Re: April 27, 2022 Planning Commission Meeting Regular Agenda Item # 6:

File # PLN2014-00430: Connect the Coastside (CTC)

The comments below are an updated summary of Midcoast ECO's previous comments to date on the CTC draft plans, with a focus on the more recent October 2021 draft.

Attachment: Proposed Short-term CTC Improvements to Moss Beach

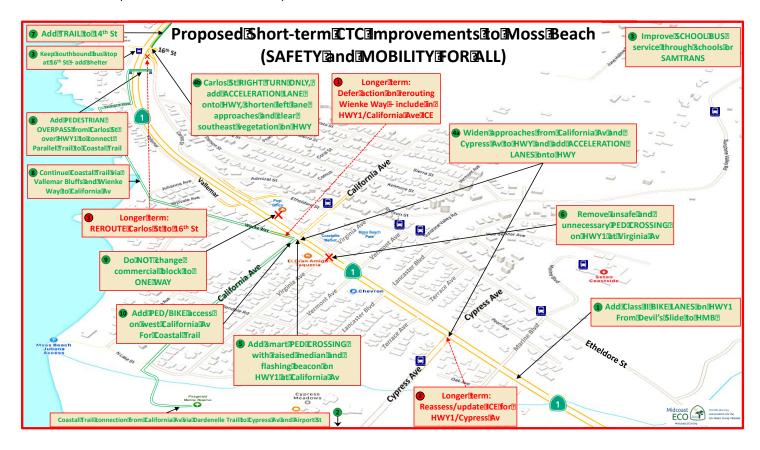
Near-term Projects (currently proposed in CTC with longer timelines - indicated **in green** on the attached map):

- 1. Add marked (Class II) bike lanes on HWY1 from Devil's Slide to HMB.
- 2. Improve bike/ped access on Airport St.
- 3. Improve bus service for schools either through the school system or through SamTrans.

- 4. In Moss Beach and Montara, consider a combination of reduced traffic speeds and acceleration lanes for cross traffic at a few intersections to provide near-term improvements to circulation and safety at low cost. Specifically,

- **a.** Widen Cypress Av and California Av approaches to HWY1, stripe separate lanes for right and left turns onto the highway and add acceleration lanes on the highway for left turns from Cypress Av and California Av.

- **b.** Upgrade the HWY1/Carlos St north intersection: no left turn from Carlos onto HWY1, add median on Carlos to channel right turn traffic onto the highway, add a right turn acceleration lane on the highway, clear vegetation on the south facing berm of the highway to improve sight distance. Also, shorten the HWY1 left turn lane approaches north to the Lighthouse and south to Carlos St to provide better separation from the left turn lane for 16th St and to eliminate "suicide arrows".

- 5. Add smart pedestrian crossings on HWY1 with raised medians and flashing beacons at California Av and 2nd St. (exclude Cypress Av and 16th St explained below).

- 6. Remove the unsafe and poorly-located crosswalk at HWY1/Virginia Av.
- 7. Complete the Parallel Trail section between 16th St and 14th St in Montara to provide a much-needed safe route from Moss Beach to Farallone View Elementary School.

- 8. Do not extend the parallel trail on Carlos St between 16th St and California Av. Instead, construct a new HWY1 pedestrian overpass bridge near the north end of Carlos Street connecting Carlos to the MWSD frontage road. This bridge could connect the Parallel Trail from Montara to the Coastside Trail, via Vallemar Av to the Vallemar Bluff Trail or Julianna Av, then proceeding via Weinke Way to California Ave.

- 9. Do not change Carlos St in the Moss Beach commercial area to one-way. The change is not adequately justified, will add to highway congestion, create confusion and inconvenience for residents and visitors and will likely result in a net increase in VMT.

- 10. Improve bike/ped access on California Av west for Coastal Trail connection to Airport St via Dardanelle/Bluff Trails and Cypress Av. Don't encourage bike/ped use of Cypress Av west, as it is too narrow and unsafe and cannot be easily widened due to the creek.

Longer term projects (should be reassessed after the above improvements are in place and include the use of updated traffic data at that time - indicated **in red** on the attached map):

- Perform ICE for HWY1/California Av. Include Coastal Trail access here and compare various signalization and roundabout options. Include options assessment for Wienke Way.
- 2. Reassess/update ICE for Hwy1/Cypress Av. Focus on vehicle traffic improvements only. Do not encourage bike/ped traffic on Cypress Av west.
- 3. Reassess the HWY1/16th St intersection and the Carlos/16th St realignment.
